ADDENDUM #2

- A. Project Name: Iowa Judicial Branch Building Chiller Replacement
- B. Owner: Iowa Judicial Branch
- C. Owner Project Number: JBFSS2425B
- D. Engineer: Resource Consulting Engineers, LLC.
- E. Engineer Project Number: 2025.023.00.
- F. Date of Addendum: 10/03/2025

IOWA JUDICIAL BRANCH BUILDING CHILLER REPLACEMENT

1 GROUND LEVEL - MECHANICAL PIPING PLAN - DEMOLITION
 1/4" = 1'-0"

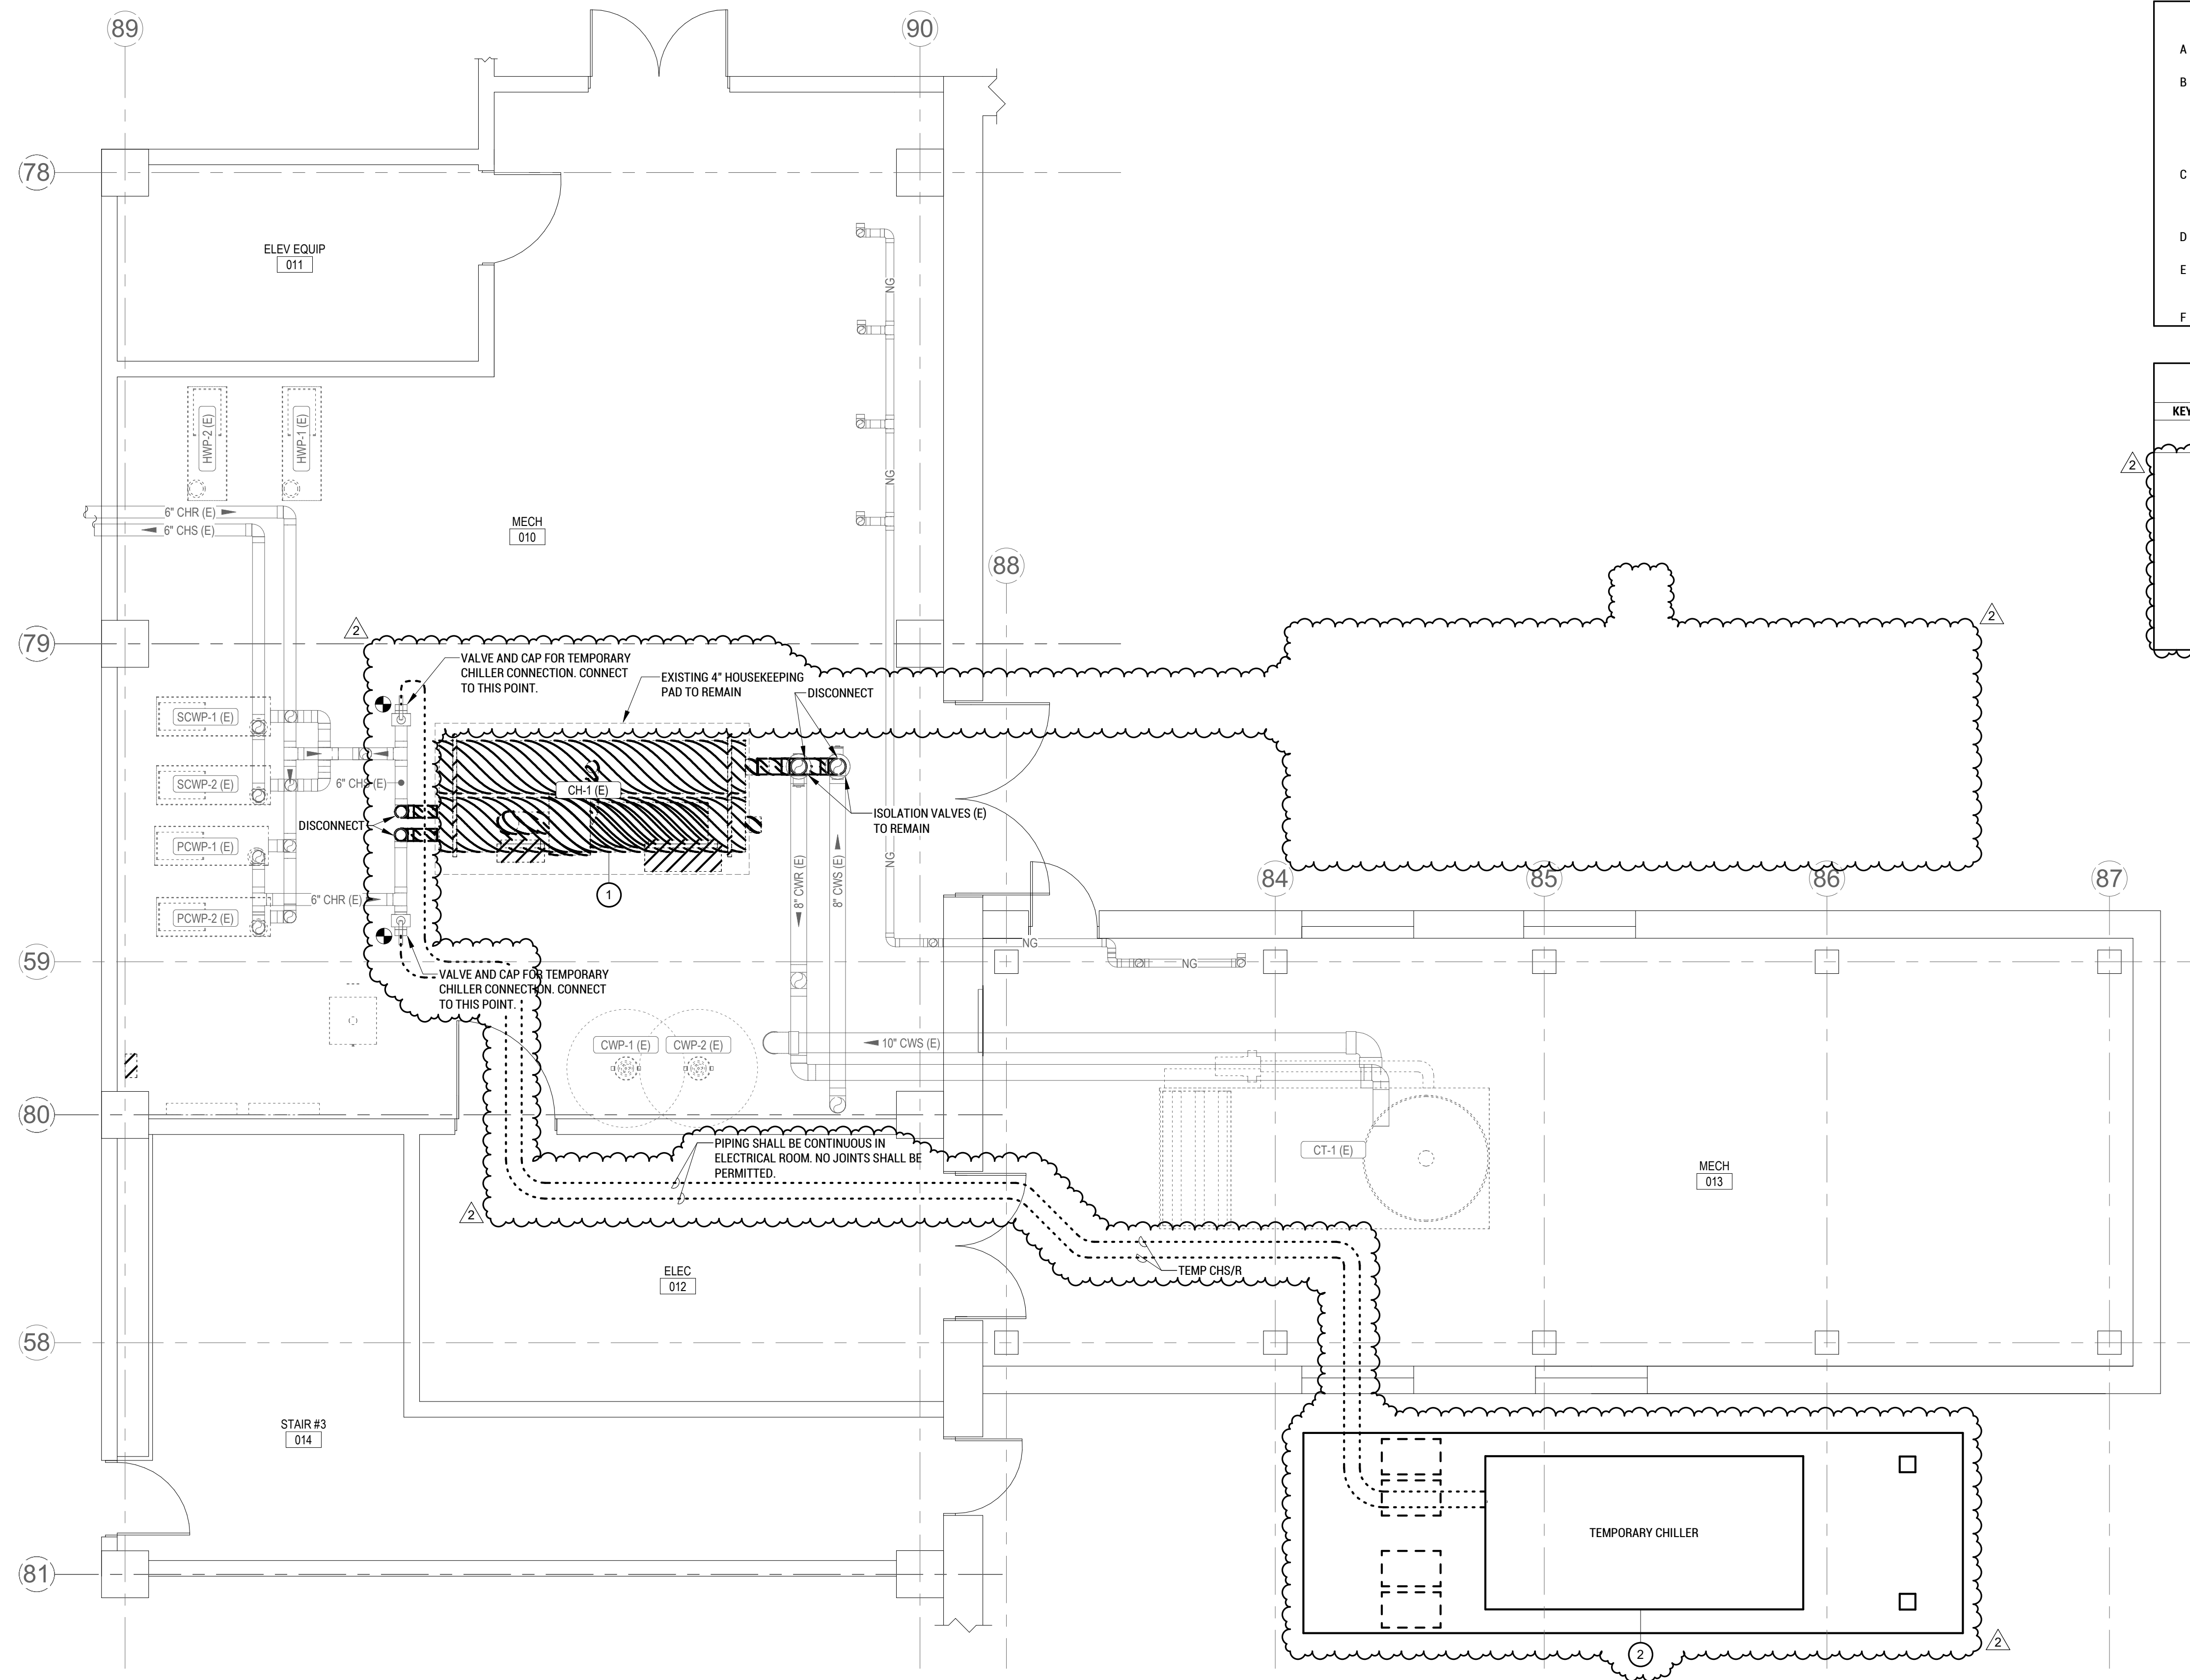
- A. Drawing MD201 – GROUND LEVEL – MECHANICAL PIPING PLAN – DEMOLITION
 1. Revise drawing per full size drawing attachment. See attached drawing MD201.
- B. Drawing M201 – GROUND LEVEL – MECHANICAL PIPING PLAN – NEW WORK
 1. Mechanical Piping General Notes. Delete “Note I”. See attached drawing M201.
- C. Drawing E201 – GROUND LEVEL – POWER PLAN – NEW WORK
 1. New and Demo Switchboard MDP Schedules: Reuse the existing 600A frame circuit breaker serving the original chiller to serve the new chiller. Replace the existing 350 amp trip plug with a new 300A trip plug.
 2. Mechanical Equipment Connection Schedule: The existing feeder to the original chiller may be reused to feed the new chiller, if feasible. This feeder is routed under the floor slab. Coordinate with feeder entry point of new chiller being provided.
